PLAN REVIEW SHEET

2017-198

WaterWalk Real Estate Services, LLC

Bus stop pad detail

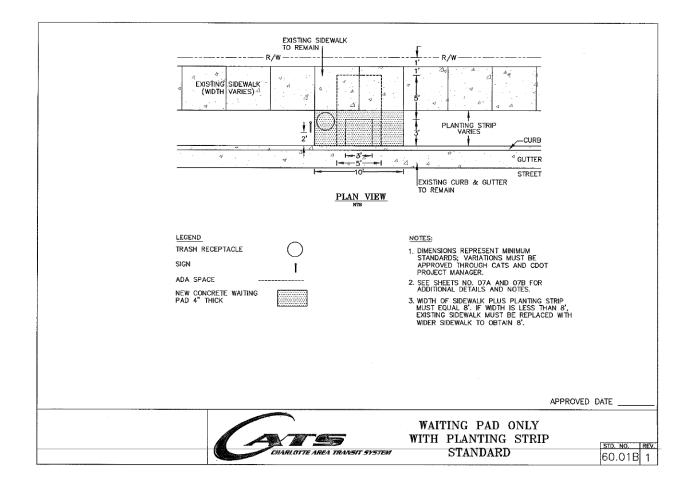
This site is along an existing bus route. The Petitioner is requested to provide and construct a new waiting pad for a relocated stop on Arrowood Road along this site's frontage, where not conflicting with a right-turn lane, and connecting to the new proposed sidewalk along Arrowood Road.

Below is an image of the standard detail (60.01B) for the requested bus stop pad. Permanent easement is requested, where dimensions exceed existing or proposed right-of-way limits.
